The Metropolitan Borough of Stockport (Hazel Grove (A6) to Manchester Airport A555 Classified Road) Compulsory Purchaser Order 2013 and

The Metropolitan Borough of Stockport (Hazel Grove (A6) to Manchester Airport A555 Classified Road) (Side Roads) Order 2013

Public Local Inquiry – 30th September 2014 – Proofs of Evidence

Proof of Evidence of
John Seed MA (Oxon) FRICS FAAV
For
David Charles Jones and Richard Anthony Jones

The Authority's Drawing No. 1007/3D/DF7/A6/MA/GA/308 to show width of existing access track

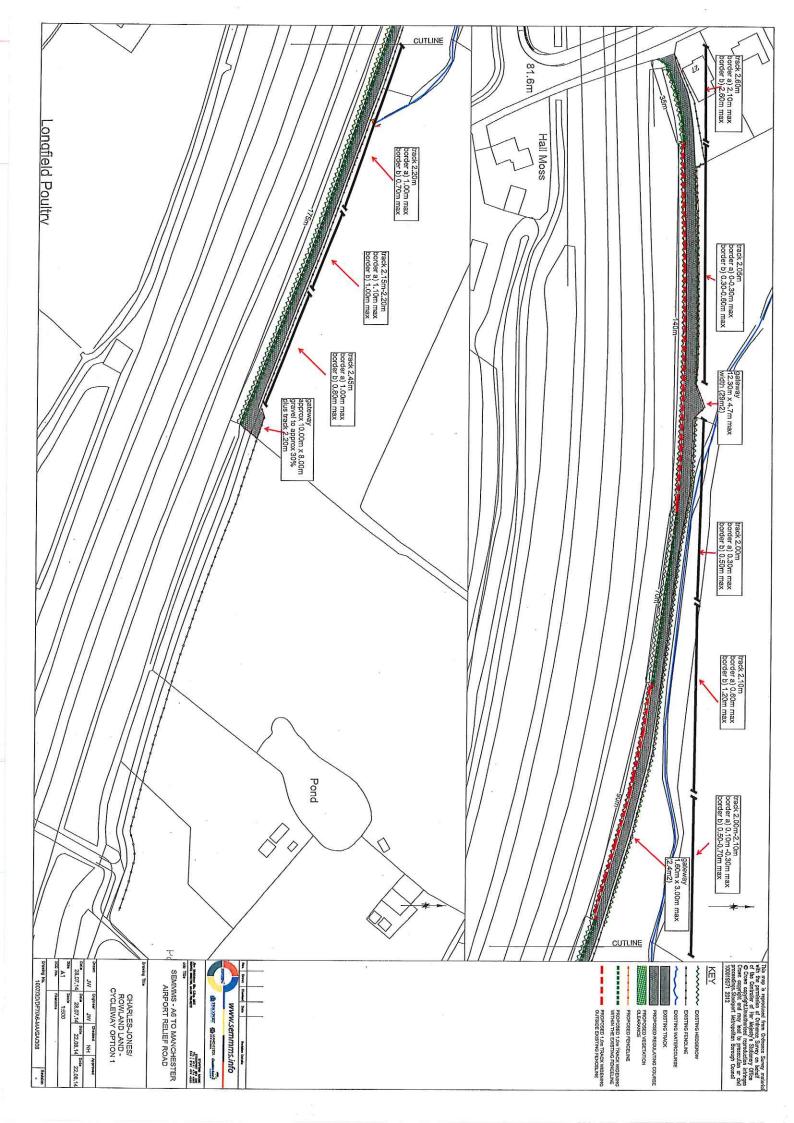
- 4.1 The track which is subject to the Authority's bridleway proposal was created specifically to deal with severance of lands to the north of the (existing) A555 road, and compensation was settled on the basis that full rights of way would be provided along the track to the subject land. It is the only means of access to the land.

- 4.4 There is a sufficient footpath network in the area.
- 4.5 The existing track is in practical terms not wide enough for modern agricultural traffic: tractor widths are routinely 2.4 metres and hay harvesting equipment 2.6 metres: these compare with the current track width shown on the drawing at Appendix 1.5.2. The measurements taken on site for Appendix 1.5.2 followed hedge cutting; when hedges grow out, the practical widths available are less. There is insufficient width for modern farm machinery and other traffic to pass along the existing track.

- 4.6 In the circumstances introducing new pedestrian, cycle and equestrian traffic creates a safety hazard which offends one of the key objectives of the scheme.

It appears that such standards have not been considered in the design process.

- 4.11 The Authority's first response to our clients concerns was to design occasional passing places. This proposal does not deal with our clients concerns as new users of the bridleway will not necessarily give way to existing agricultural traffic, meaning that agricultural traffic may have to reverse to the nearest passing place (notwithstanding any cyclists, horse riders etc. behind as well as in front of the vehicles.

- 4.13 The Authority's second response was to widen the track by 1 metre (possibly including fencing). This was proposed in the email referred to above of the 5th August 2014 in which it was stated "SMBC has modified the scheme to allow for the widening of the line by 1 metre along its length, as per the attached plan. Please advise your clients accordingly." The latter comment is symptomatic of the Authority's attitude it prefers to impose solutions rather than consult and discuss them. The additional 1 metre width is insufficient for horse riders.

- 4.8 The client has put forward a practical proposal involving the provision of a new track within the claimant's landholding, immediately to the north of the line of the existing hedge between the track and land affected by the proposal. The new track would be used solely by the claimant for agricultural and equestrian purposes, and will be maintained at the claimant's expense. This would leave the existing track (other than at its opening from Hall Moss Lane) to be used entirely by new pedestrian, cycle and equestrian traffic. This deals with all safety concerns (the opening at Hall Moss Lane could be widened to enhance safety).

- 4.9 The cost of a new 3.2 metre wide agricultural track, to include a new fence to the retained land, would be in the region of £25,000 to £34,000, depending on whether the surface base can be locally excavated material or imported (Ref. extract from John Nix Pocket Book at Appendix 1.5.2).
